# CALIFORNIA REGIONAL WATER QUALITY CONTROL BOARD SAN FRANCISCO BAY REGION

ORDER R2-2008-0026 NPDES PERMIT NO. CA0037958

# AMENDMENT OF WASTE DISCHARGE REQUIREMENTS ORDER NO. R2-2004-0093 FOR NOVATO SANITARY DISTRICT, NOVATO, MARIN COUNTY

Discharge Facility Treatment Process Diagrams

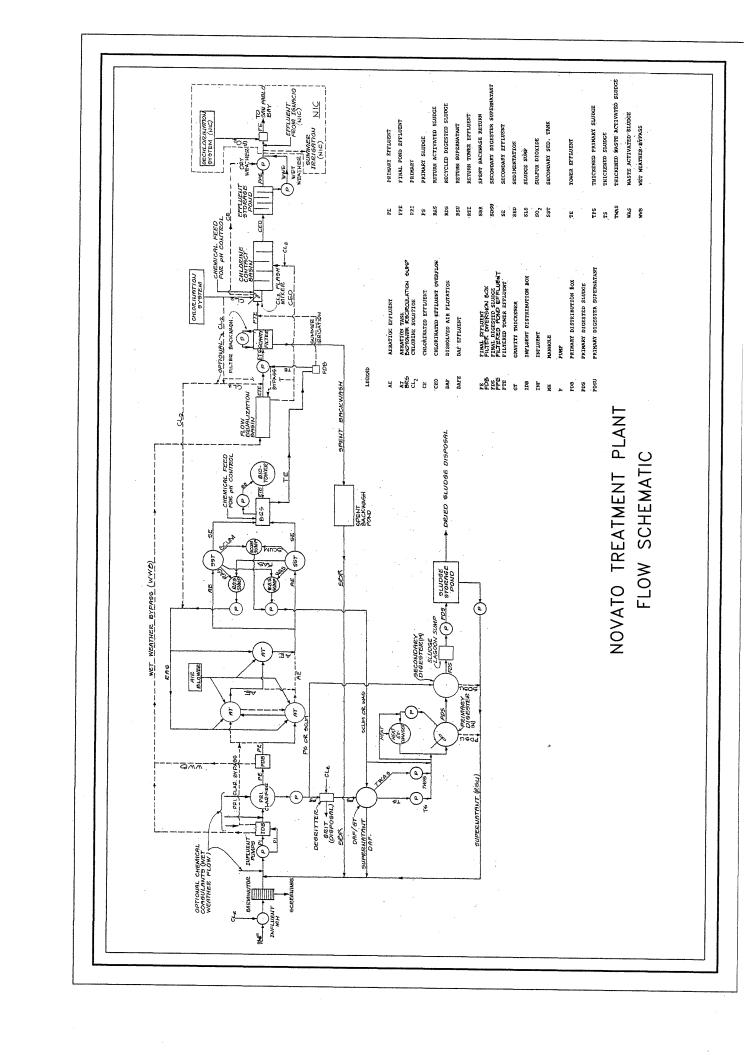
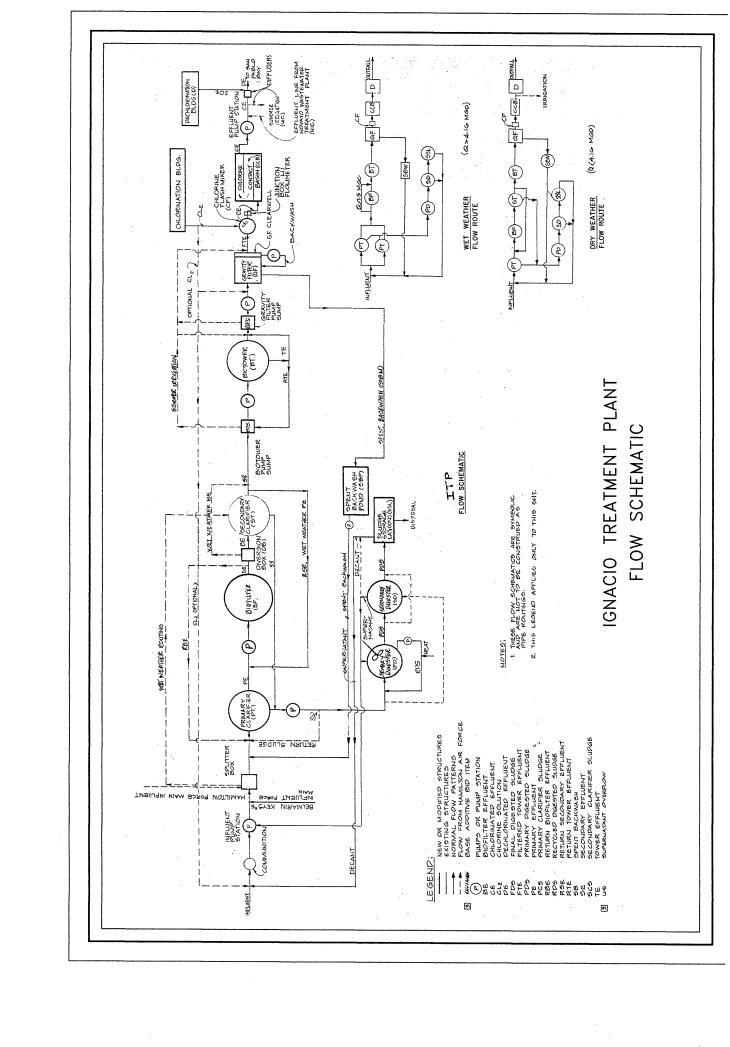
# 3. Replace Attachments A and B with revised figures (attached).

Provision 3 replaces Attachments A and B with revised figures that update the discharge location and treatment process.
